**ADDENDUM # 1**

<b>Project</b>	TA Blakelock High School Renovations	<b>Project No.</b>	2215-C
<b>Location</b>	1160 Rebecca Street, Oakville, ON	<b>Date of Issue</b>	2025 04 24
<b>Owner</b>	Halton District School Board	<b>File</b>	2215/7.1.3

This Addendum forms part of the Contract Documents and amends the original Drawings and Specifications, dated 2025 04 17, and all preceding Addenda, as noted below.

4 PARTIAL FLOOR PLAN - LEVEL 1 & 1A  
A101-D 1:50

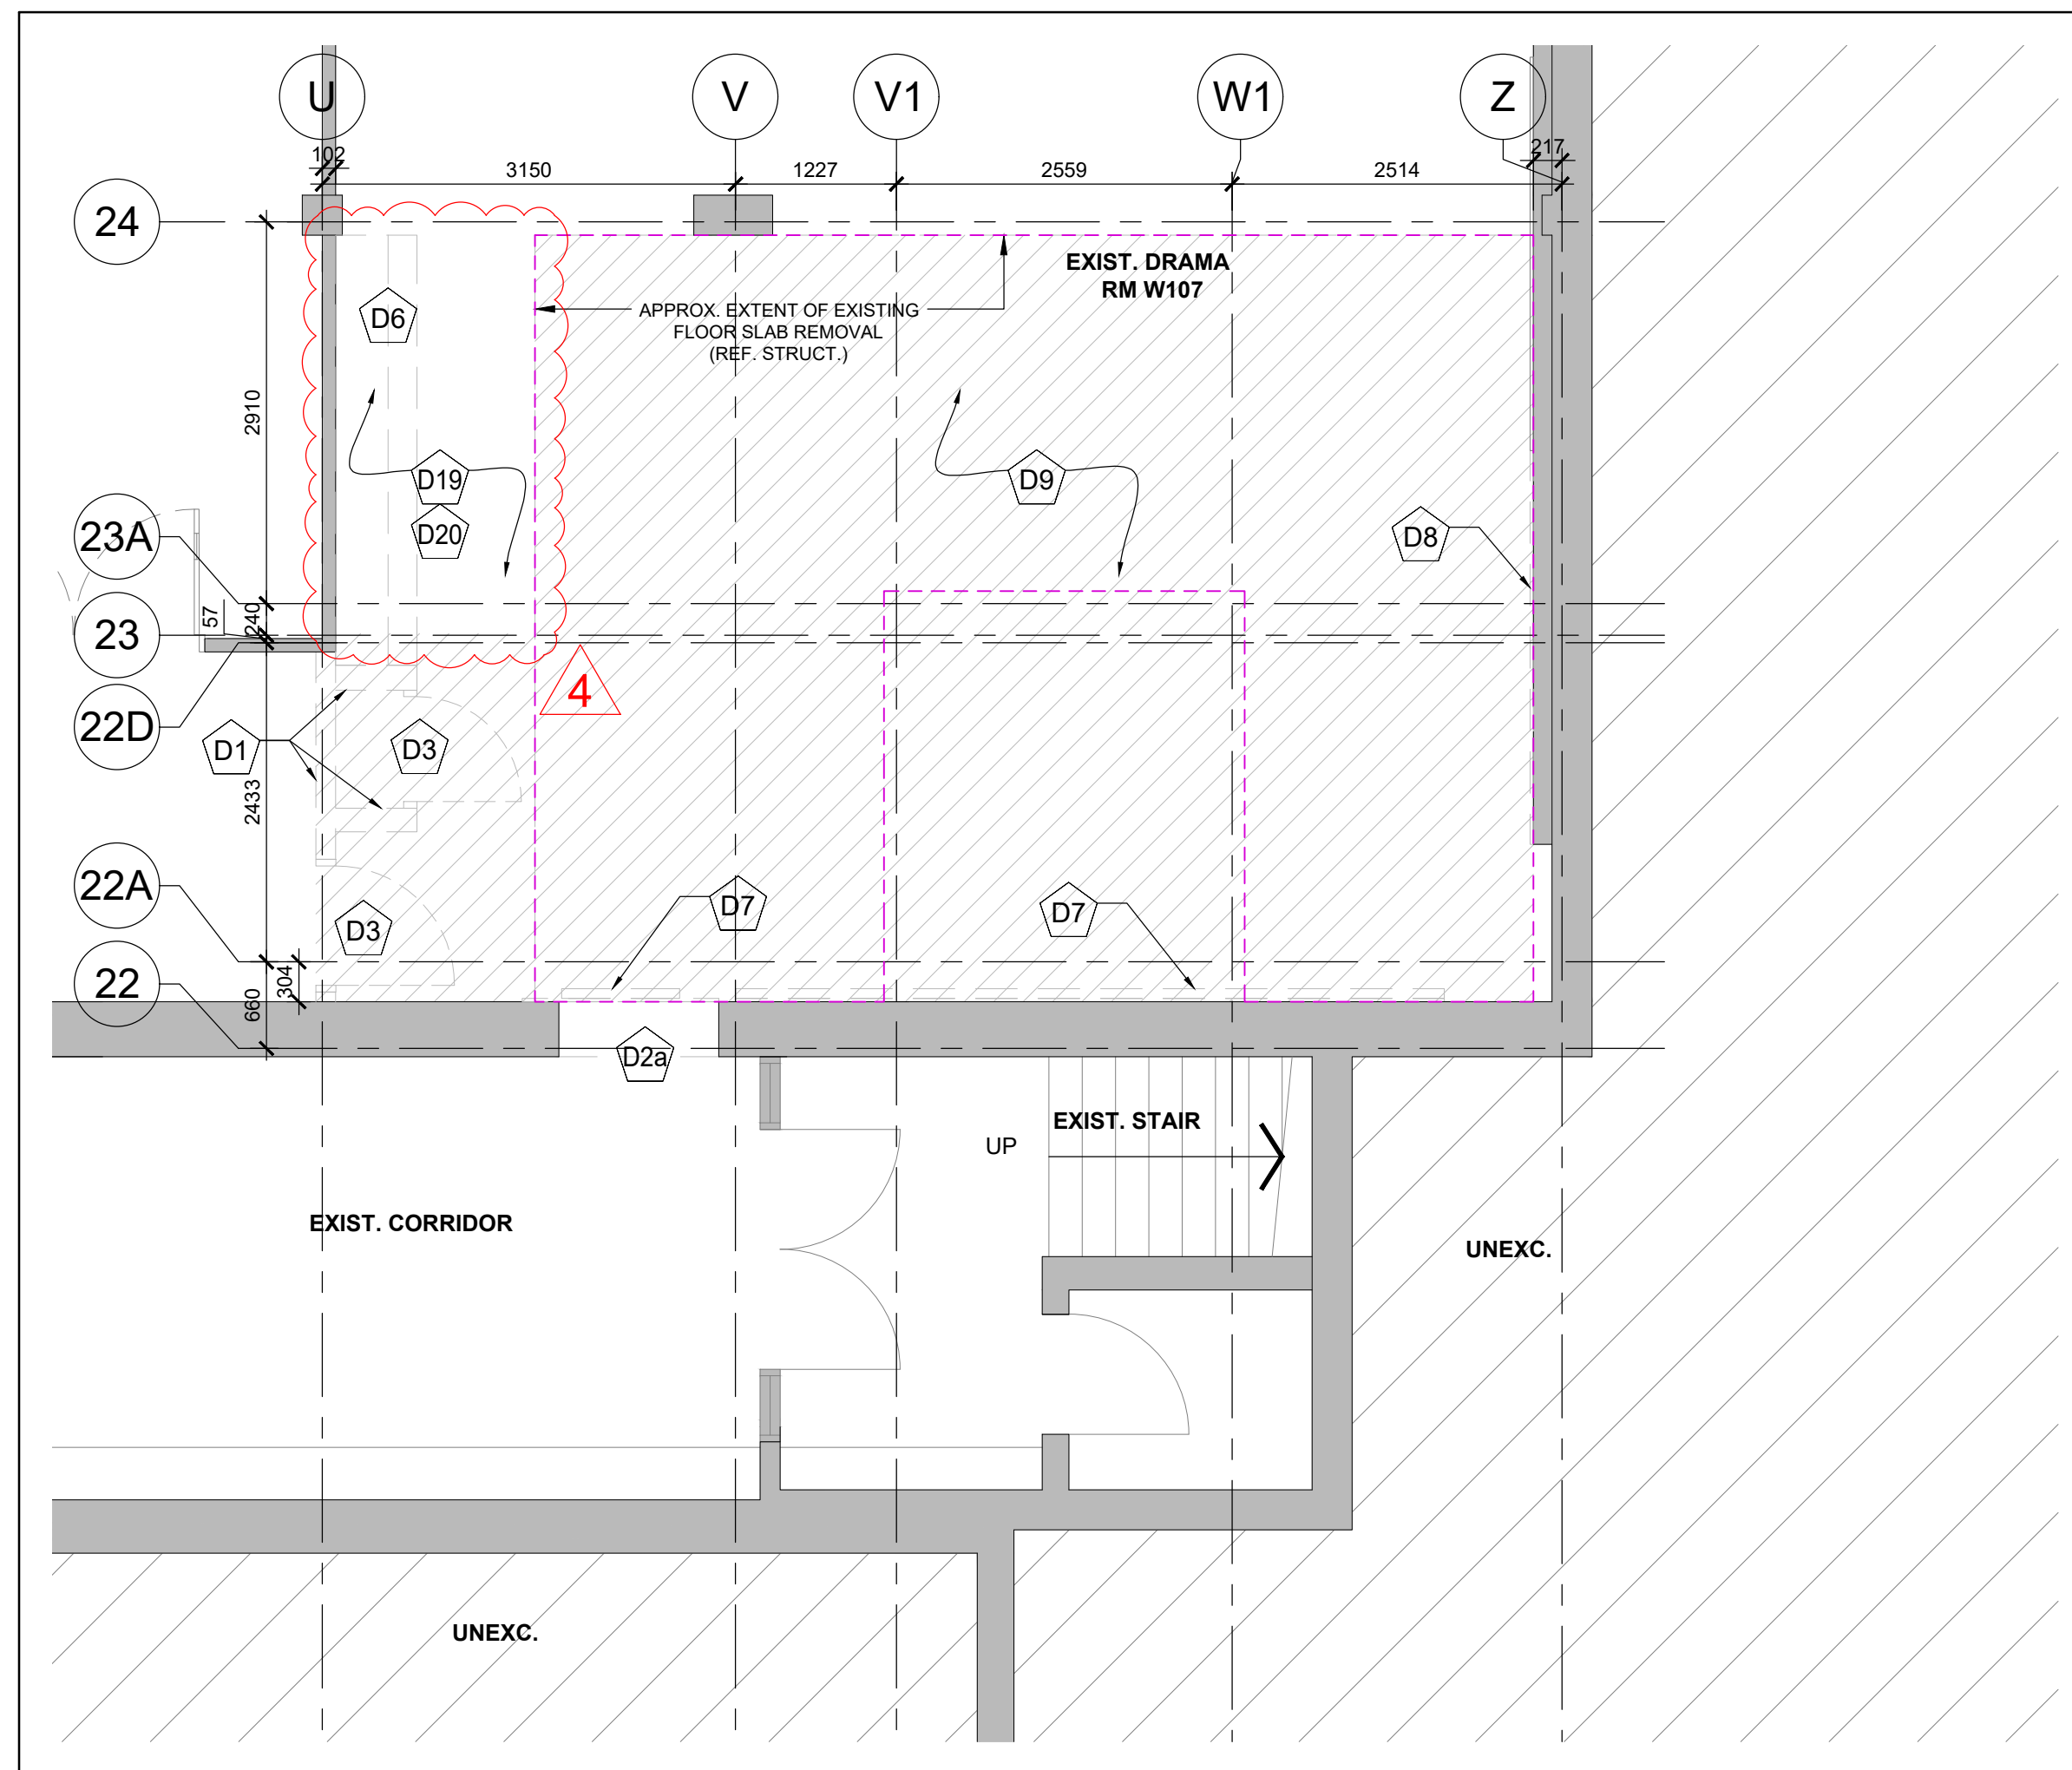
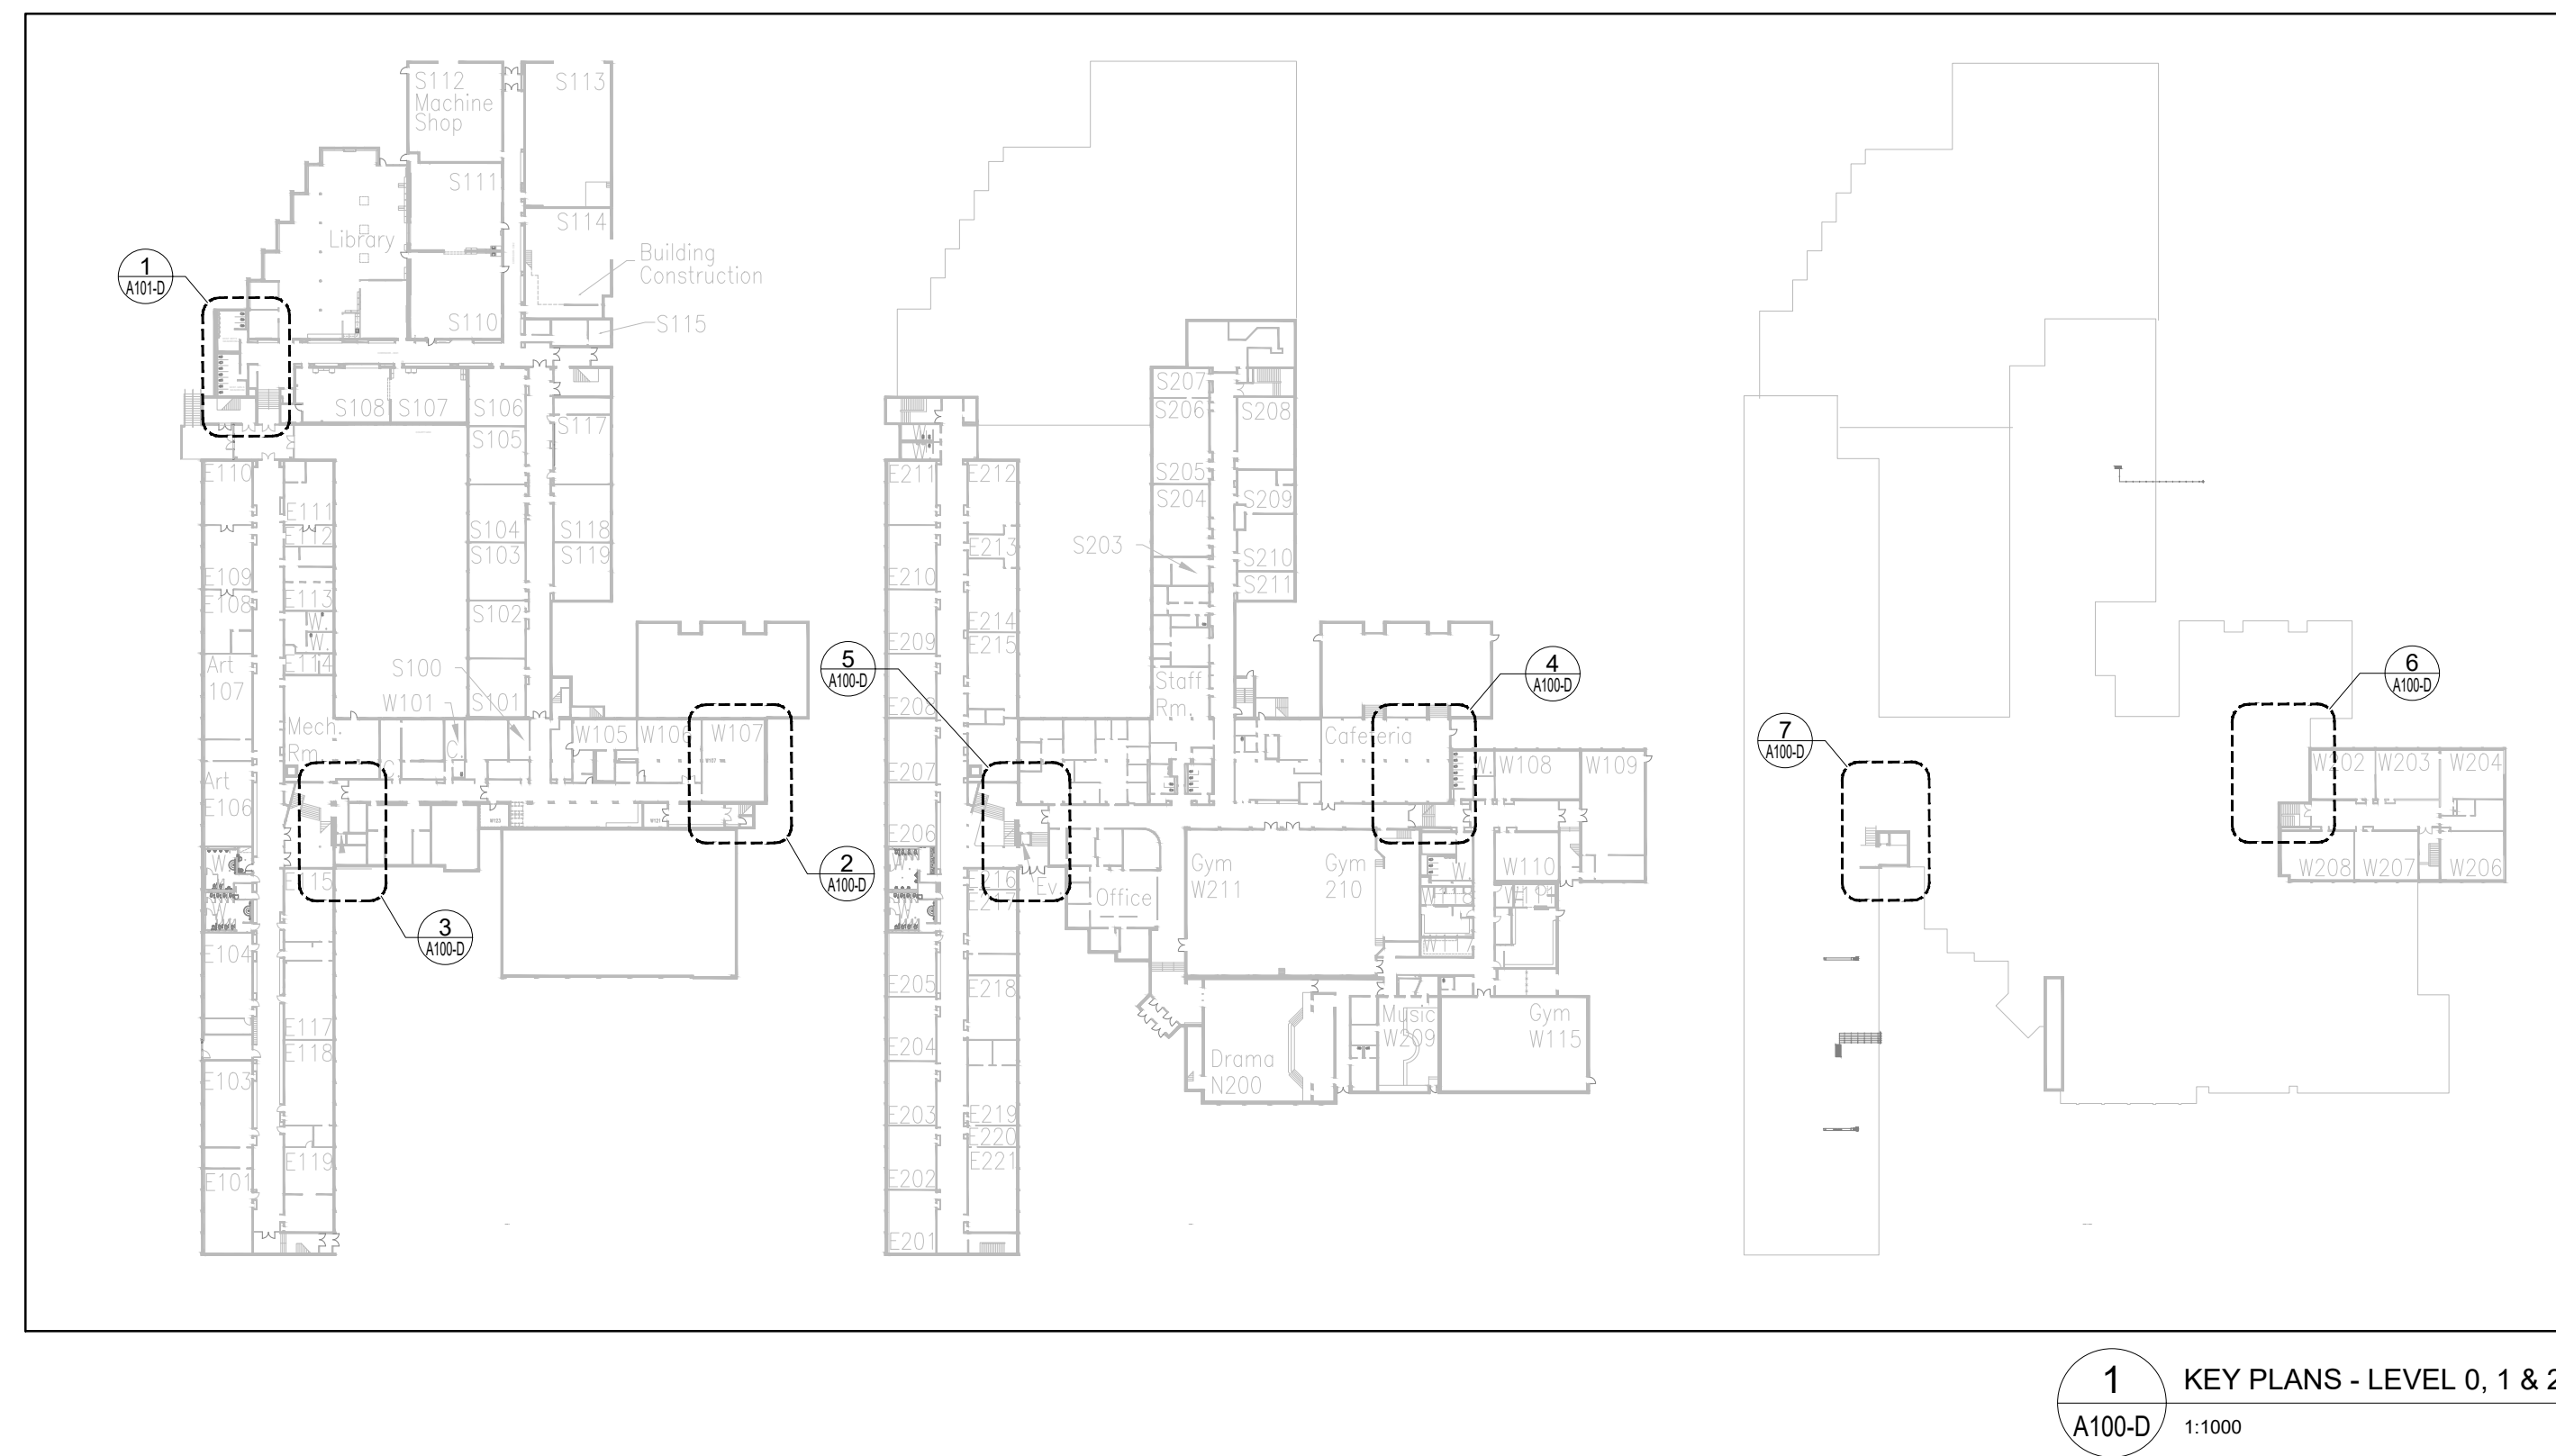
- .1 Replace drawing with the attached Revision No. 4.
- .2 Drawing reissued to clarify demolition scope and include additional Demolition Notes D15-D20.
